CITY OF ALBUQUERQUE

Re: Crestline
2635 Baylor Dr. SE
Traffic Circulation Layout
Engineer's/Architect's Stamp 08-07-19 (M16-D044)

Based upon the information provided in your submittal received 09-04-19, the above referenced plan cannot be approved for Building Permit until the following comments are addressed:

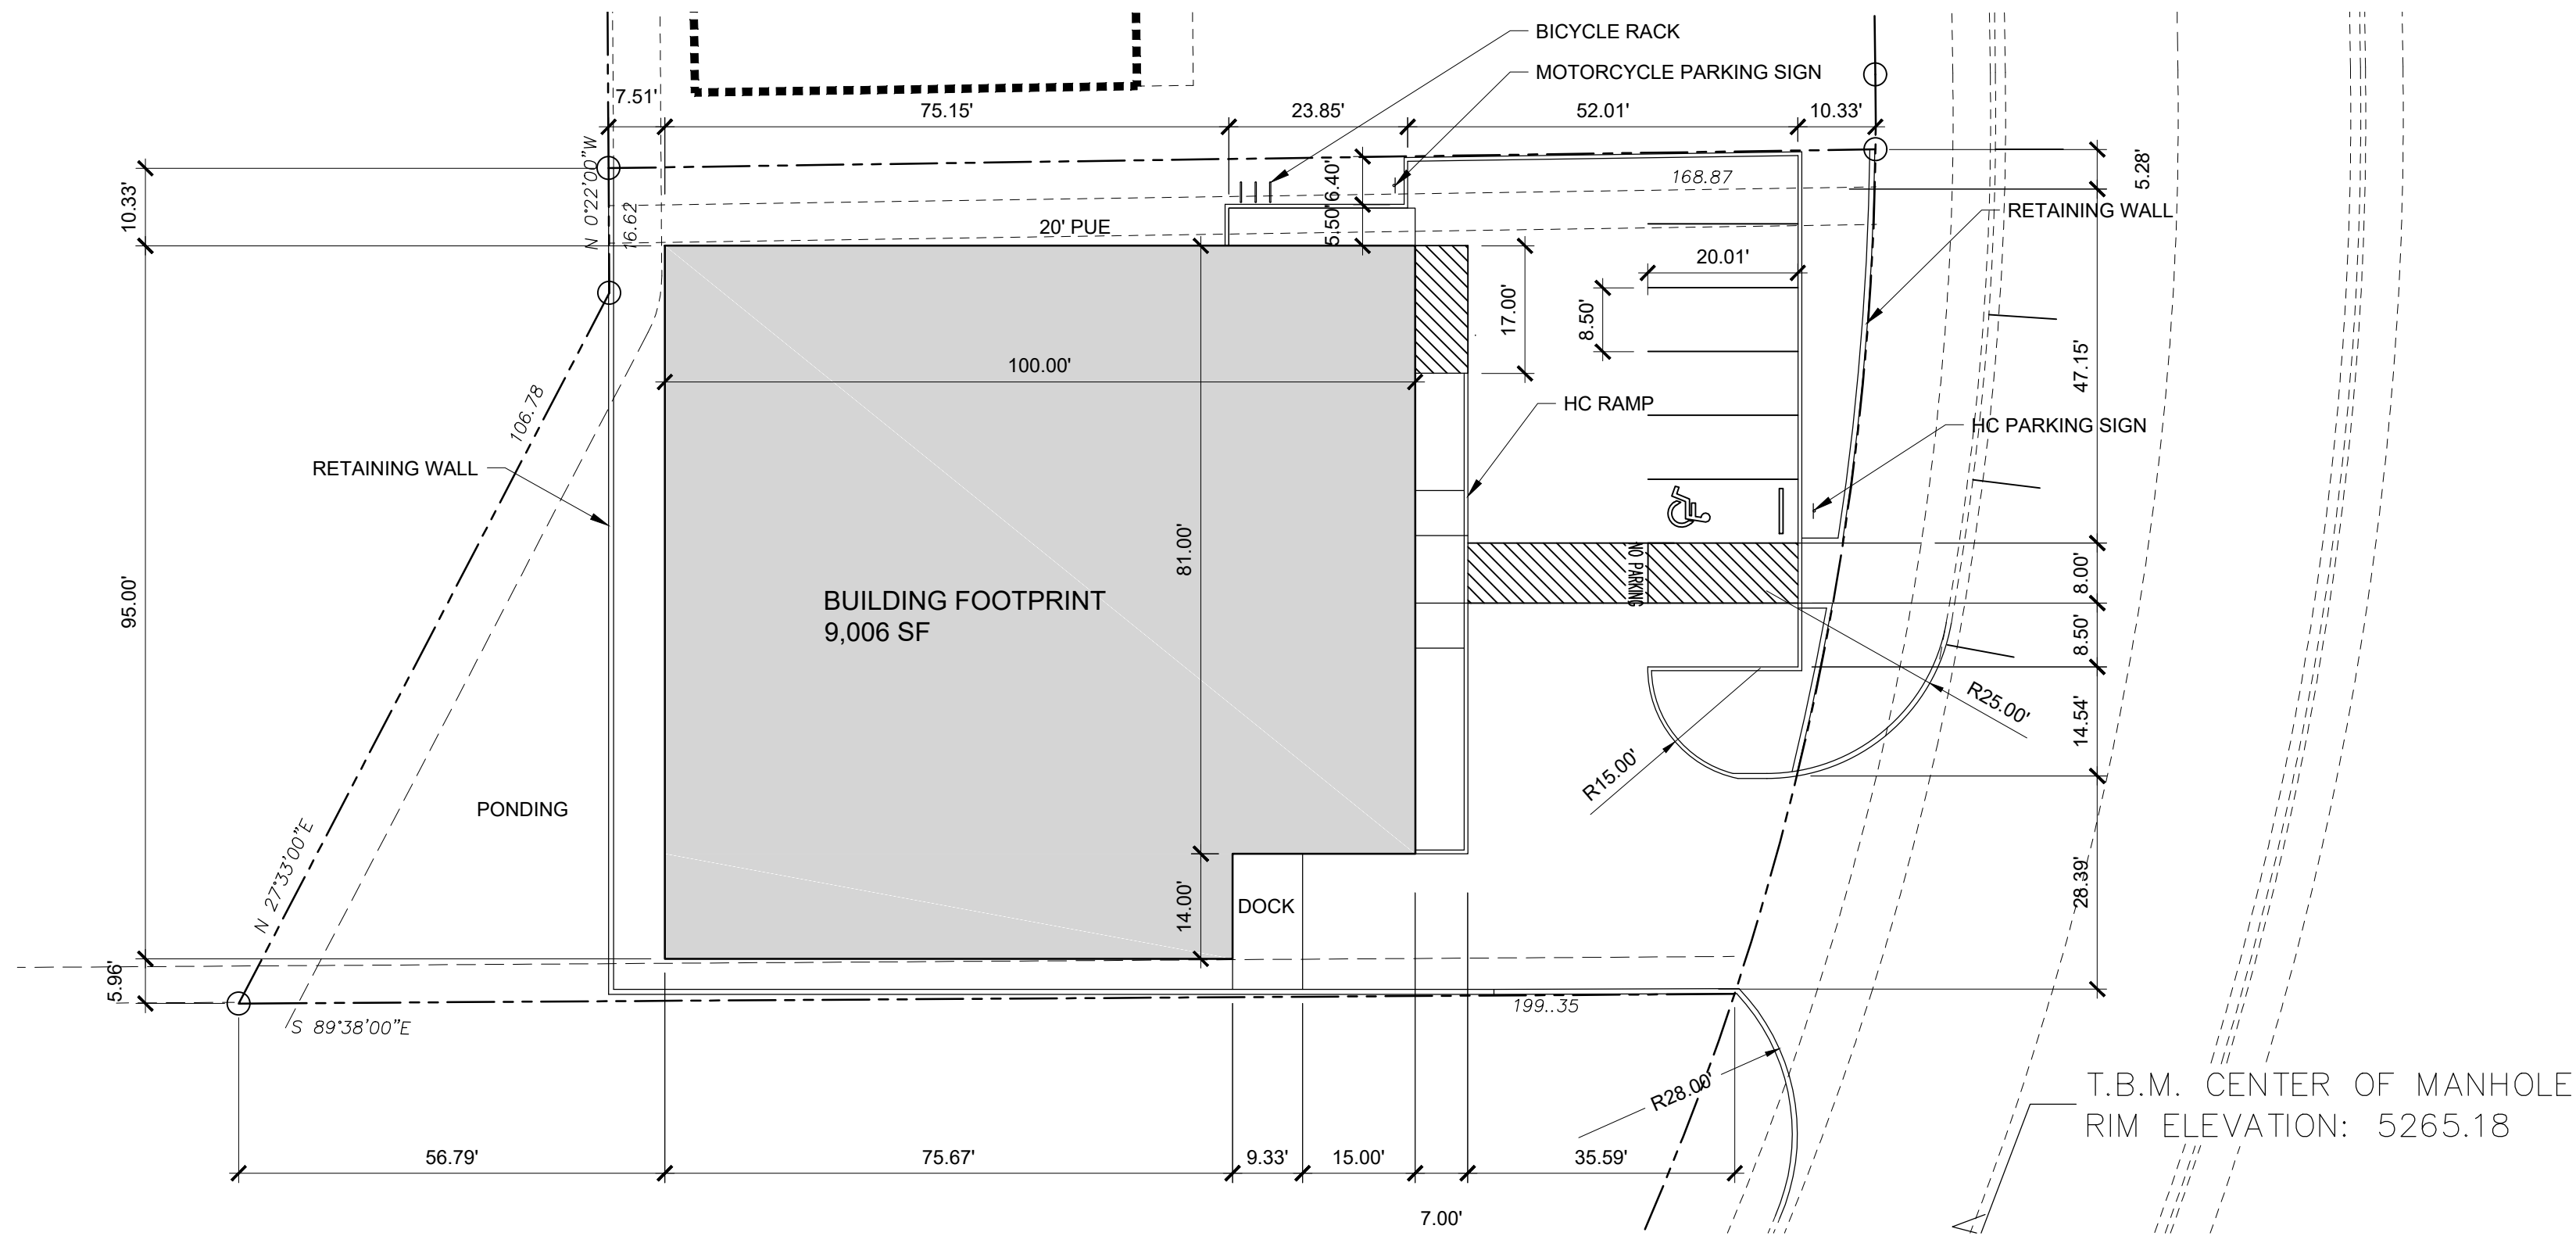
1. Identify the right of way width, medians, curb cuts, and street widths on Street(s) Name.
2. Show grade in the parking area specifically the ADA space.

3. Show all drive aisle widths and radii. Some dimensions are not shown.
4. Refuse vehicle maneuvering shall be contained on-site.The refuse vehicle shall not back into the public right of way.; provide a copy of refuse approval.

5. Show the clear sight triangle and add the following note to the plan:
"Landscaping and signage will not interfere with clear sight requirements. Therefore, signs, walls, trees, and shrubbery between 3 and 8 feet tall (as measured from the gutter pan) will not be acceptable in the clear sight triangle.

6. The existing curb cut is bisected by the property line as shown on AGIS website. Please clarify. Is the access you are showing is a new access?
7. Please show the existing sidewalk and curbe and gutter and show how you are tying it with your proposed curb.
